Case Officer Conclusions / Report

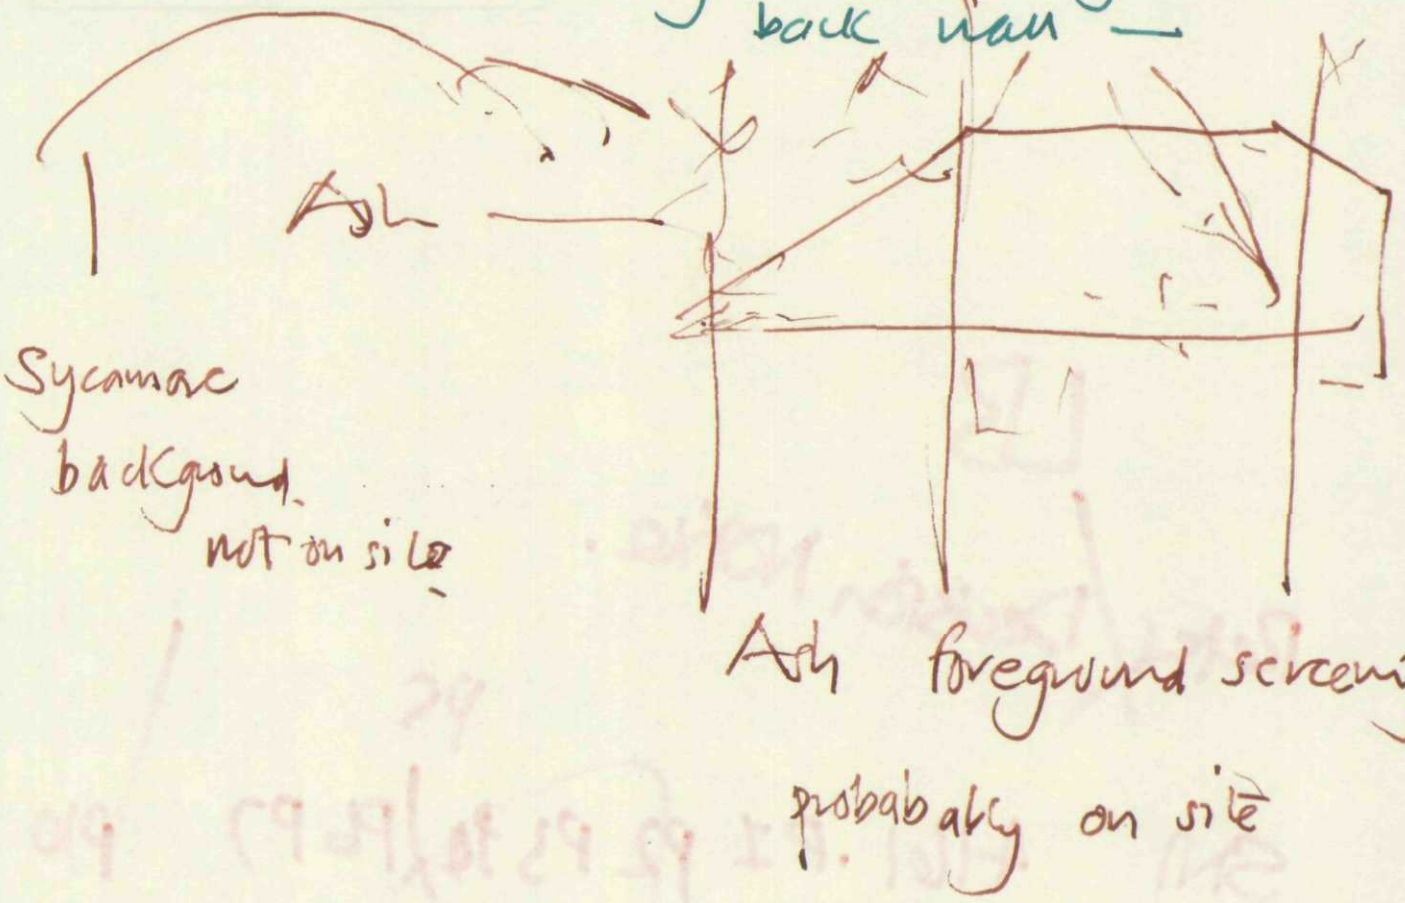
13 new bedrooms 3 and a lounge in re-built coachhouse. Building Inspector confirms that it will need to be dry-lined if solid construction and otherwise consistent with Bldg Regs MRW 06 · OCTR

Is open area on ground floor compatible with historic building – loss of large area of back wall –

Sash forms for shutter.

Ownership issue not fully resolved.

Private flats – still included.
